# Access Compliance Report

## Public Rights-of-Way

### (Curb Ramps)

Intersection ID: 11867	Main Street: E_17TH_ST	Cross Street: SEIGLE_AV	Location:	N
ADA ID: 79499FB1AE95	Ramp Type: Perp	Initial Pass/Fail: Fail	Overall Compliance: No	Severity Score: 37.5

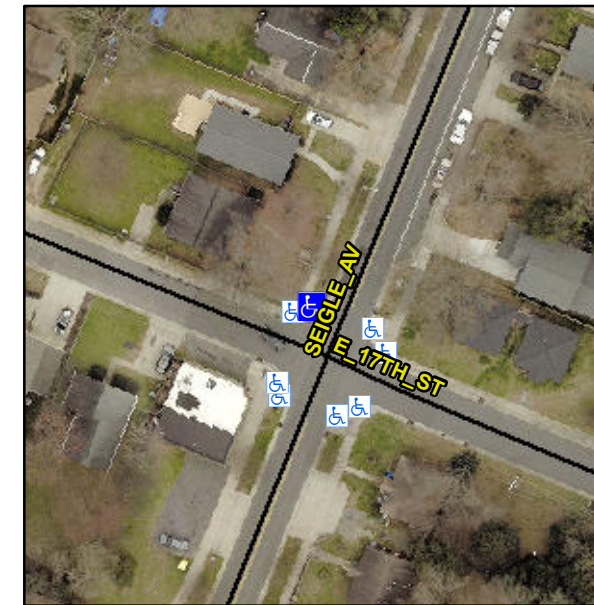
**Not Found, R304.2.2, R304.5.3**

Compliance	Description	Data	Compliance	Description	Data
N/A	Ramp Length (in)	85.0	No	Ramp Slope (%)	9.1
Yes	Ramp Width (in)	48.0	No	Ramp XSlope (%)	7.2
N/A	Flare Type LT	N/A	N/A	Flare Type RT	N/A
N/A	Flare Slope LT (%)	N/A	N/A	Flare Slope RT (%)	N/A
N/A	Flare Traversable LT?	N/A	N/A	Flare Traversable RT?	N/A
N/A	Landing Length (in)	N/A	N/A	DWS Provided?	N/A
N/A	Landing Width (in)	N/A	N/A	DWS Contrast?	N/A
N/A	Landing Slope (%)	N/A	N/A	DWS Length (in)	N/A
N/A	Landing X Slope (%)	N/A	N/A	DWS Full Width?	N/A
N/A	Landing Curb? (Y/N)	N/A	N/A	DWS Offset (in)	N/A
N/A	Shared Landing?	N/A			
N/A	Gutter Ponding?	N/A	N/A	Gutter Slope (%)	N/A
N/A	Gutter Lip Ht (in)	0.5	N/A	Gutter X Slope (%)	N/A
N/A	Painted X Walk1?	No	N/A	Painted X Walk2?	N/A
	X Walk 1 Direction	To SE		X Walk 2 Direction	N/A
N/A	X Walk 1 Width (in)	N/A	N/A	X Walk 2 Width (in)	N/A
	X Walk 1 Slope (%)	1.6		X Walk 2 Slope (%)	N/A
	X Walk 1 X Slope (%)	6.0		X Walk 2 X Slope (%)	N/A

**Remove & Replace Entire Ramp.**
